SUBDIVISION REVIEW SHEET

CASE NO.: C8-2022-0147.0A

SUBDIVISION NAME: Maxwell Subdivision

**CITY OF AUSTIN –DEVELOPMENT SERVICES DEPARTMENT
SUBDIVISION APPLICATION – MASTER COMMENT REPORT**

FINAL PLAT MAXWELL SUBDIVISION

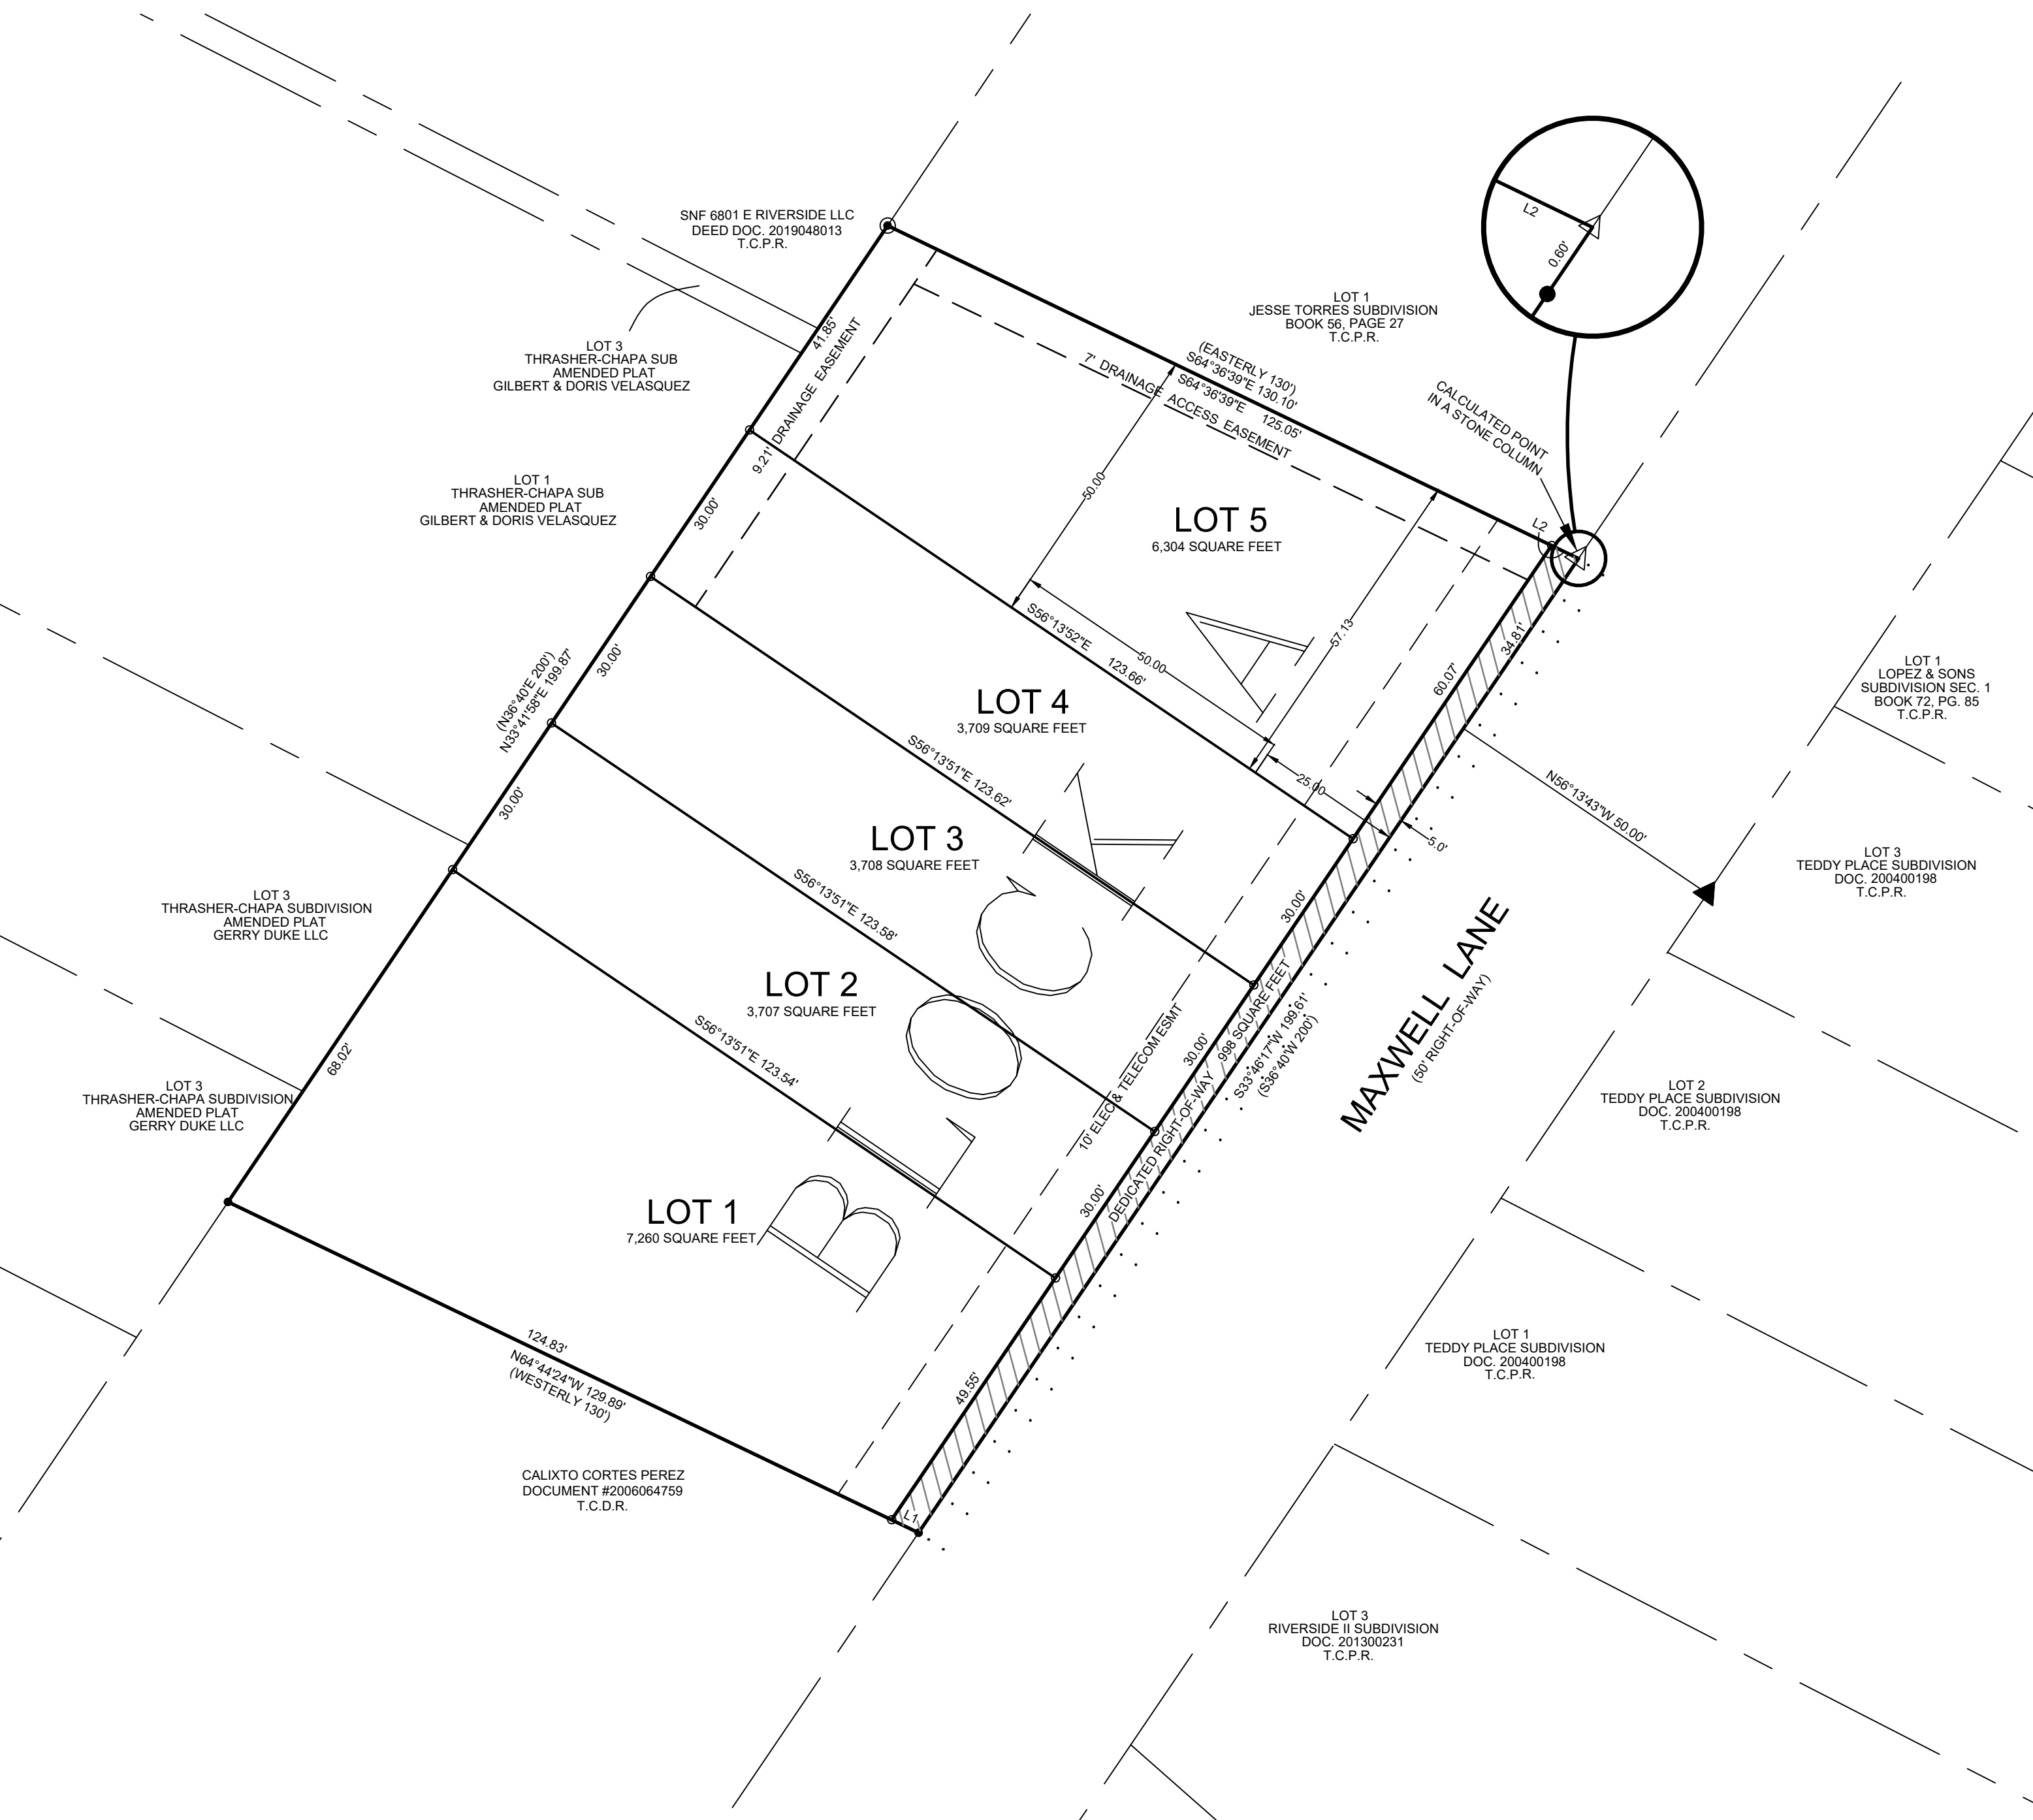
- SR 6. Show all existing easements on the plat, annotate easements accordingly if provided by separate instruments. (L.D.C 25-1-83)

Clarify if drainage easements will be recorded by separate document(s) or by plat. If separate easement documents will be filed, annotate the easements on the plat to include the document numbers for the recorded easement(s).

- SR 14. Add a note on the plat that list the lots that will have Cottage Uses.

Update 1: Also include a note on plat Sheet 2 listing the lots that will have cottage use.

WQ 2. Provide an exhibit that demonstrates how each lot will convey runoff to a water quality control. It appears that runoff from Lot 4 and Lot 5 will bypass the sedimentation basin. The lot fronts are graded away from the water quality control and into the right of way. Water quality controls are required per LDC 25-8-211.

Update #1: It remains unclear how runoff generated from the proposed onsite impervious cover is conveyed to the proposed water quality pond. The flows arrows indicate that the front ends of Lots 2-5 do not convey runoff to the pond. Additionally, a splitter box is not proposed to divert the volume of runoff greater than the water quality volume away from the proposed pond.

Update #1: The proposed water quality pond must be located within a Drainage Easement with Require Maintenance since it will be privately maintained. Additionally, since the pond will be shared between lots, a legal document that ties the lots together for the purposes of drainage and water quality is required.
